TRANSITION TO SAP PART NUMBER IN REC SERIES MARKING

Product Information Notification

Product Group: SF/Thursday April 9, 2026/PIN-SF-00496-2026-REV-0

ANNEX 1 – EXAMPLES PICTURES OF EVOLUTION

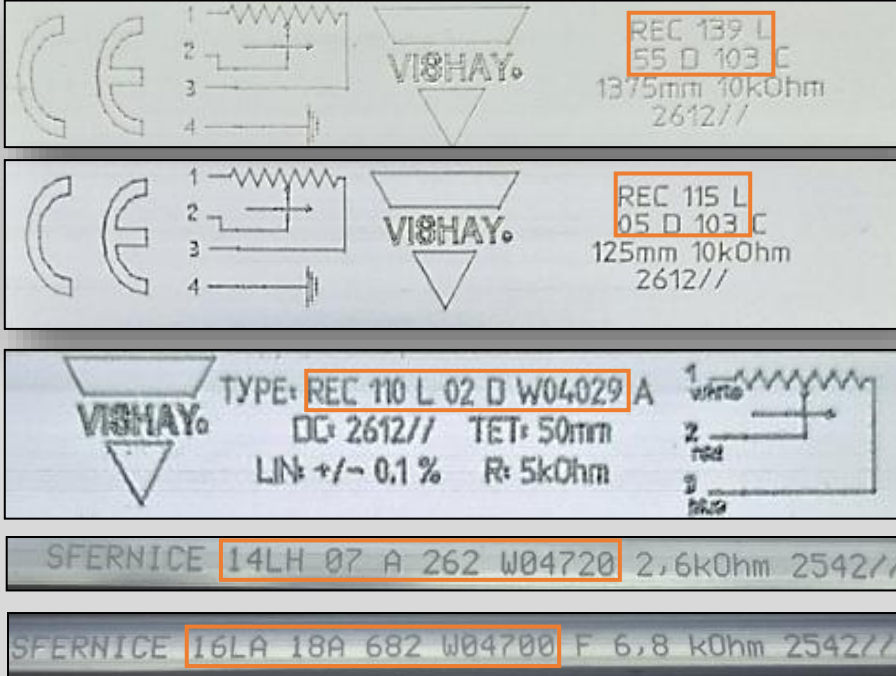
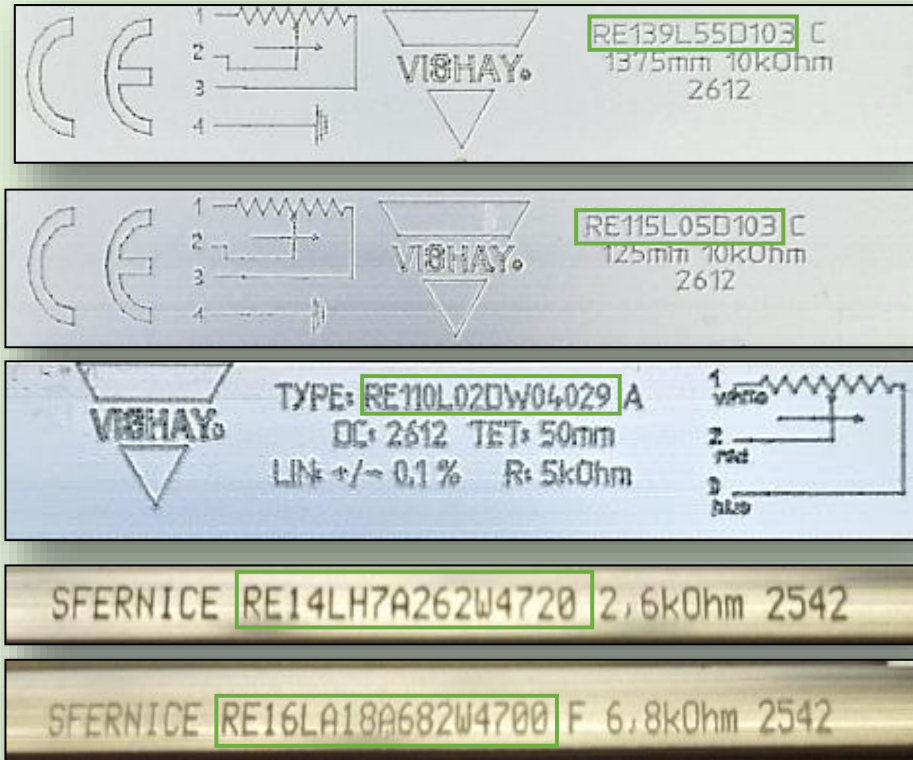
Description of Change: As part of our ongoing commitment to improving product identification and optimizing internal processes, the complete SAP Part Number will now be included in the marking of below listed series, replacing the previous description.

(Cf. appendix of this PCN for examples/pictures of the future marking)
